UCC28780

SLUSD12A –OCTOBER 2017–REVISED FEBRUARY 2018

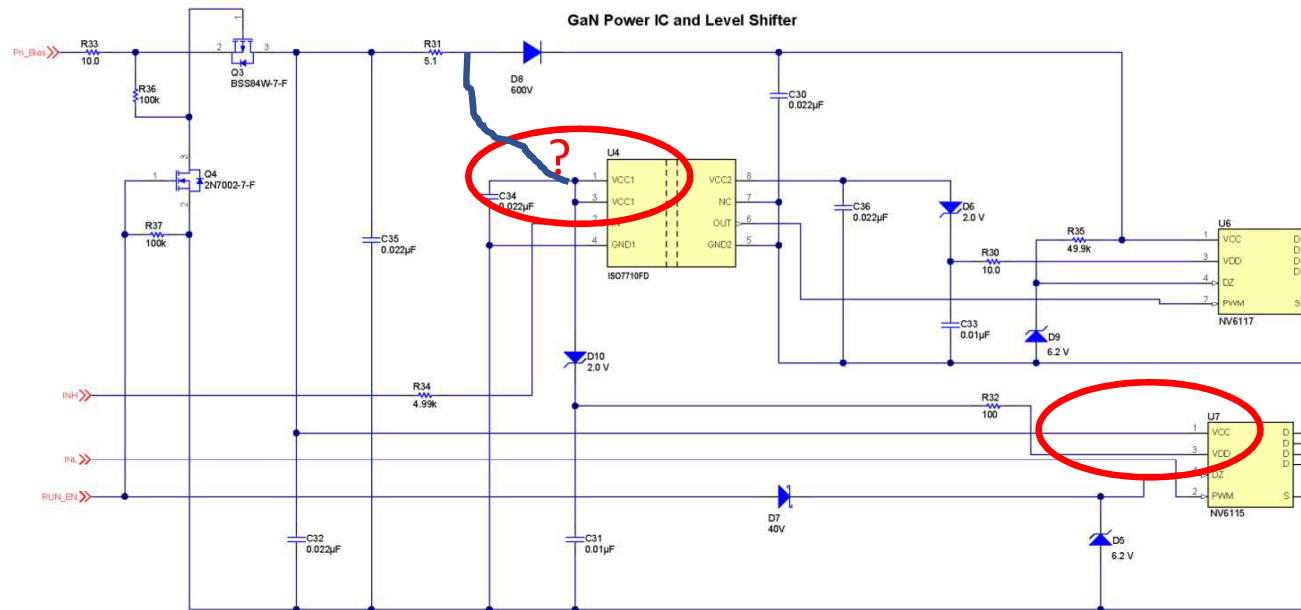
MISSING VCC1 AT U4 & thus to U7?
